RESOLUTION NO. 3903

A RESOLUTION PROCLAIMING THE ANNEXATION OF APPROXIMATELY 46.54 ACRES (42.89 ACRES FOR DEVELOPMENT AND 3.65 ACRES WITHIN GRAND PRAIRIE ROAD RIGHT-OF-WAY) LOCATED SOUTH OF GRAND PRAIRIE ROAD SE AND WEST OF INTERSTATE 5 (FILE AN-05-97); APPROVING ZONING OF RS-6.5 (RESIDENTIAL SINGLE FAMILY - 6 TO 8 UNITS PER ACRE) FOR TAX LOT 1400, LINN COUNTY ASSESSOR'S MAP 11-3W-16; ADOPTING FINDINGS; AND SETTING A PUBLIC HEARING FOR THE REMOVAL OF THE NEWLY ANNEXED TERRITORY FROM THE ALBANY RURAL FIRE PROTECTION DISTRICT.

EXHIBIT E
TENTATIVE SUBDIVISION MAP
 Subdivision File M1-10-97

EXHIBIT G
APPROVED SITE PLAN
 Site Plan Review File SP-98-97

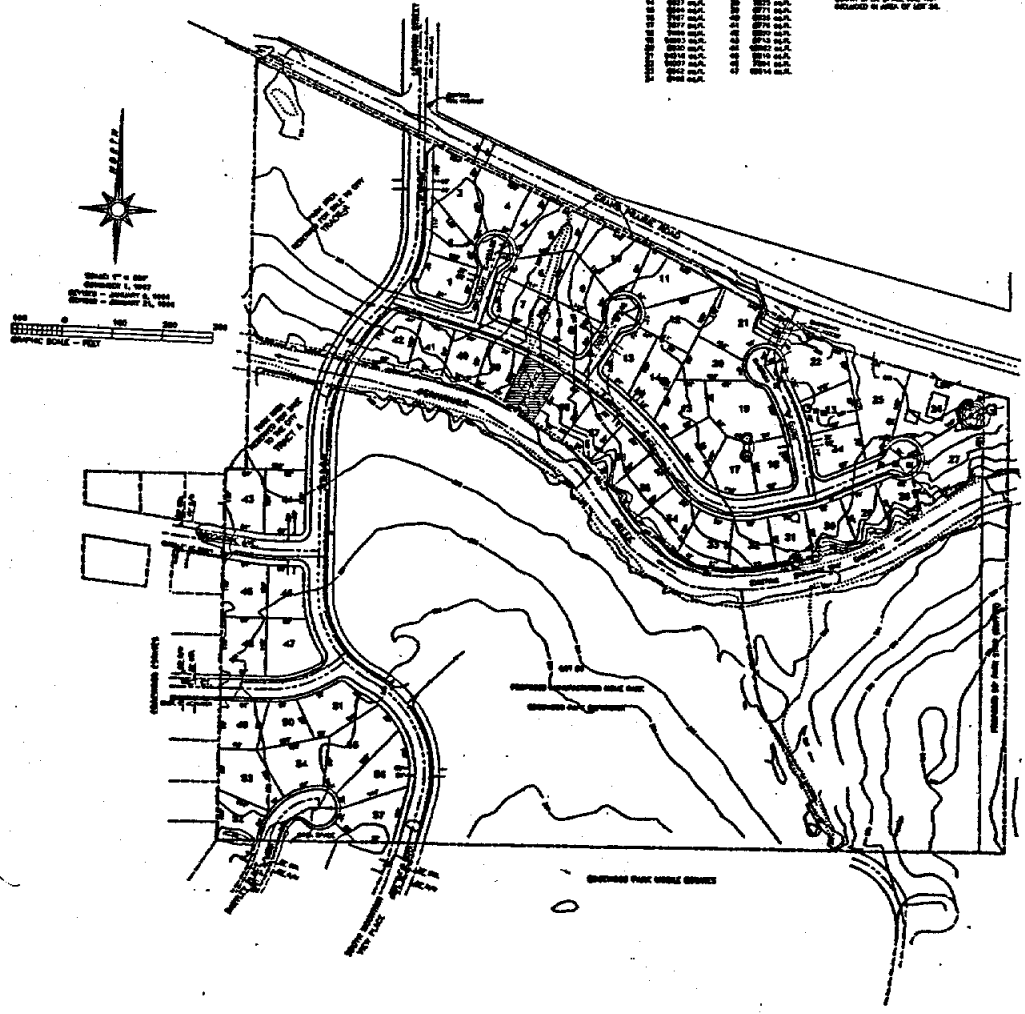
3.1 Center line curve radii for streets within the proposed subdivision shall be a minimum of 200 feet. The tentative plat appears to show a 150-foot radius curve on Heyerly Place. The final plat shall be revised to show a 200-foot minimum radius curve.

- 3.7 The speed limit for all streets within the proposed subdivision will be 25 mph, resulting in a minimum sight distance requirement at intersections of 250 feet. Several intersections along Mountain View Place appear to have sight distances slightly less than this, and will require minor alignment modifications. Because the available sight distances along Mountain View Place will be at, or only slightly exceed, the minimum required, the applicant shall construct curb extensions ("bulb-outs") at intersections along the street. Curb extensions would eliminate parking near intersections, improve visibility and sight distance, shorten pedestrian crossing distances, and function as traffic calming features by narrowing the roadway.

- 3.9 The tentative plat shows that the required 50-foot additional noise setback has been provided along Interstate 5. It is unclear who will own and maintain this area. It shall be combined with Lot 26 and/or 27 on the final plat. Who will own the area labeled "open space" west of Lot 57 on the tentative plat is also unclear. It must be combined with one of the lots shown on the plat, or otherwise combined with another parcel.

On a drawing submitted with the concurrent application to develop Lot 58 of the proposed subdivision, a 6-foot high berm, 24 to 36 feet in width, is shown to be constructed within the 50-foot noise setback for Lot 58. This berm shall also be constructed in the setback along the rest of the subdivision lots that abut I-5 (Lots 26 and 27).

- 4.11 Except as described in 4.10 above, construct the storm drainage system that will provide drainage to the proposed subdivision, as shown on the storm drain plan (revised to avoid the PER 8-A wetland). No storm drainage system is shown for Grand Prairie Road is shown. A system must be designed and constructed. No pipe sizes are shown on the plan. Final design details including alignment and pipe sizes must be reviewed and approved by the City Engineer through the Site Improvement (SI) process.

- 4.14 The area along Periwinkle Creek shown on the tentative plat that is identified as an "existing drainageway easement" shall be shown on the plat as a separate tract.

- 4.17 The existing 30-inch pipe along the west boundary of the subject property is located within a 10-foot wide public easement (Linn County deed records MF-115-795). The tentative plat does not show the easement. It appears the easement is located along the west edge of proposed Lots 43, 45, and 48. The easement must be shown on the plat.

- 4.18 The storm drain plan submitted by the applicant does not show a specific type of drainage structure where the new Mountain View Drive will cross Periwinkle Creek. This crossing must be constructed as a single span structure (either a culvert or a bridge).

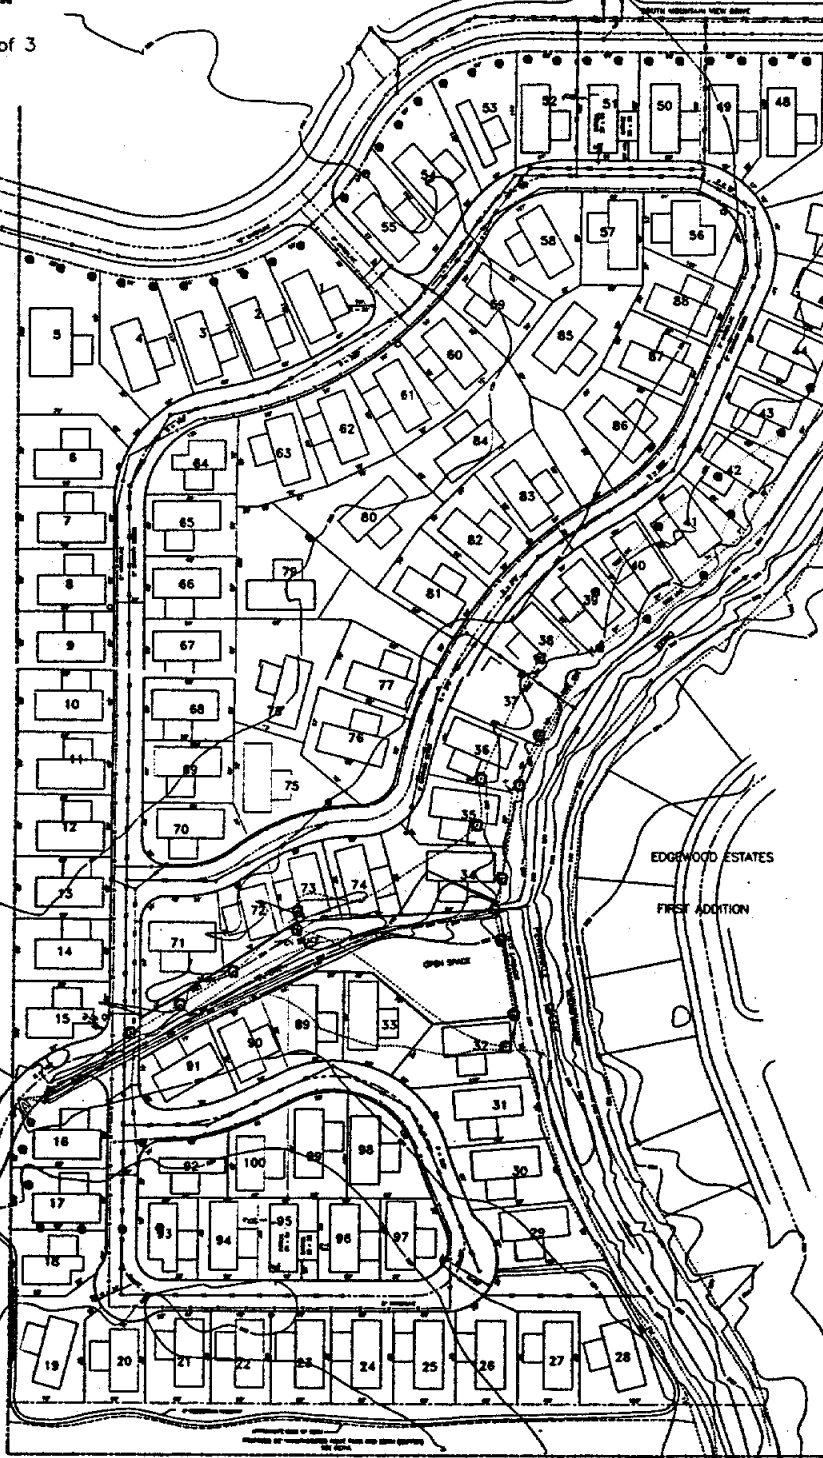
The plans that were submitted for the manufactured home park do not show a system of walkways that would meet this requirement. Sheet 3 of 3 of the plans shows a plot plan of a typical manufactured home space, with a 3-foot wide sidewalk behind the curb of the street. It is implied from this drawing that each home will be connected to the other homes by constructing sidewalks along the frontage of each space. It is feasible to do this, but it is not clear from the plan that's what is intended. In addition, the sidewalks must be 4-feet wide. A walkway that connects the streets to the proposed common area within the freeway noise buffer area and then to the existing manufactured home park to the south where most of the recreation facilities for the park expansion will be located is shown on the plans.

- 1.8 Construct the 6-foot high berm, 24-36 feet in width, and walkway shown on the plans to be constructed within the 50-foot noise setback from Interstate 5.

2.2 The applicant has agreed to set aside the wetland identified on the City's East I-5 Local Wetland Inventory as PER 8-A as "open space." This shall be done on a revised site plan for the proposed manufactured home park. A note shall be included on the plan that states no development is allowed in this area.

3.1 Provide the 20-foot wide buffer area with trees planted every 30 feet along Mountain View Drive shown on the plans. A 10-foot wide buffer is required within the 20-foot area. This buffering shall conform with the specifications listed in 3.4 below. No screening is required along this west boundary of the park.

3.3 Provide a 10-foot wide area of buffering and screening along the east boundary of the park, within the 50-foot wide noise buffer along Interstate 5. Construct the 6-foot high, 24- to 36-foot wide berm shown on Sheet 3 of 3 of the plans. This berm meets the screening requirement for this boundary of the park. (ADC 9.250 allows "an earth berm combined with evergreen plantings or a fence which forms a sight and noise buffer a least six feet in height within two years of installation.")
